2006/2007 PROPOSED CHANGES TO THE INTERNATIONAL BUILDING CODE — FIRE SAFETY

FIRE SAFETY CODE COMMITTEE

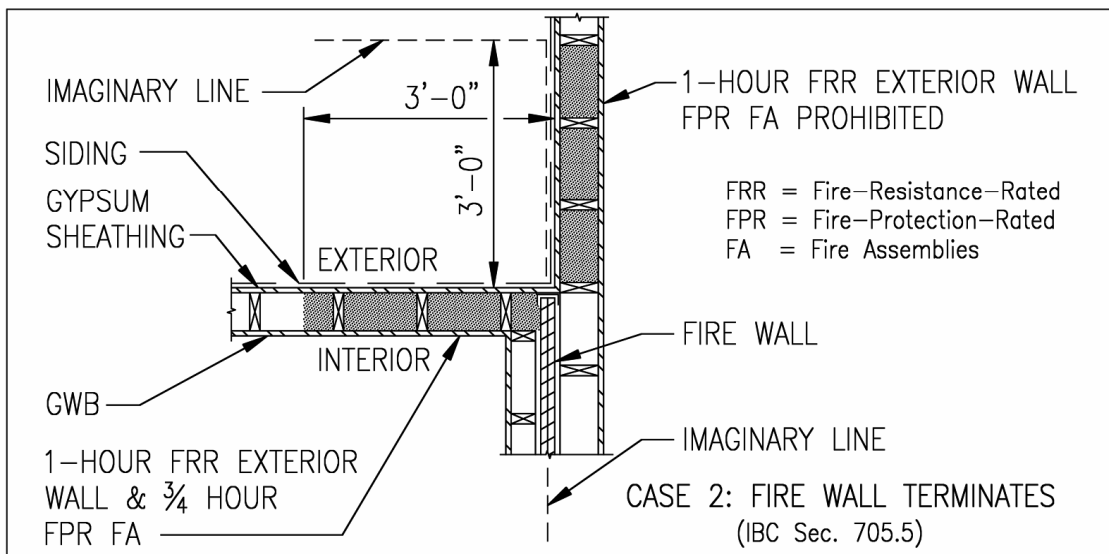
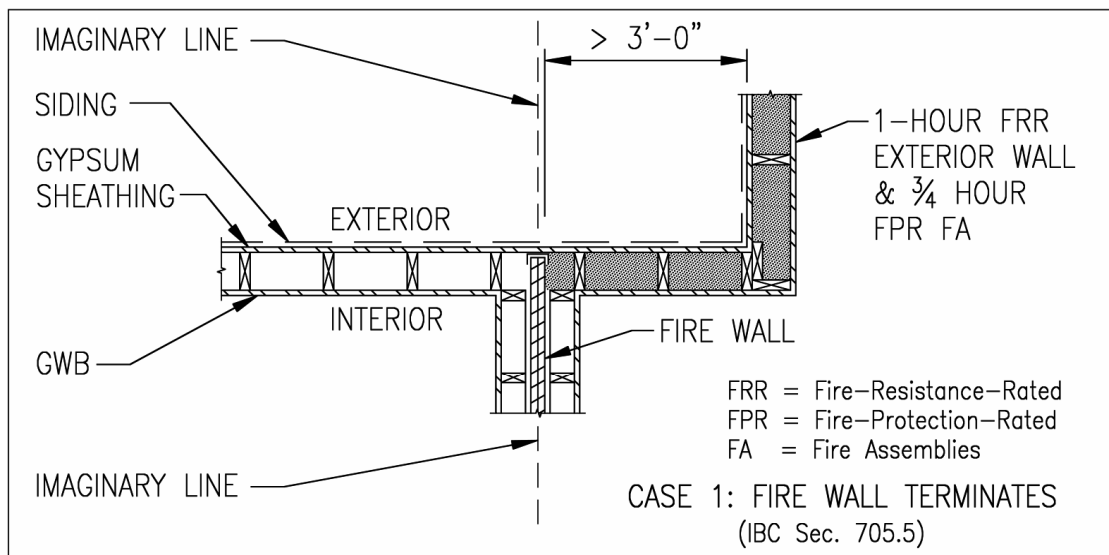
Determining the fire-resistance rating and opening protection of the exterior wall "where opening protection is required" is also problematic. The protection ought to be based on the proximity of the exterior wall on one side of the fire wall to the exterior wall on the other side of the fire wall, which is moot when the exterior angle formed by the exterior walls is equal or greater than 180 degrees.

The accompanying diagrams illustrate applications of the proposed changes requiring fire-resistance-rated construction at the exterior wall on either side of the fire wall but also permitting openings at certain fire separation distances from the imaginary line provided they are 3/4-hour fire-protection-rated assemblies. Once permitted, the allowable percentage of fire-protection-rated would be small at small fire separation distances, increasing at larger distances until unprotected openings are permitted.
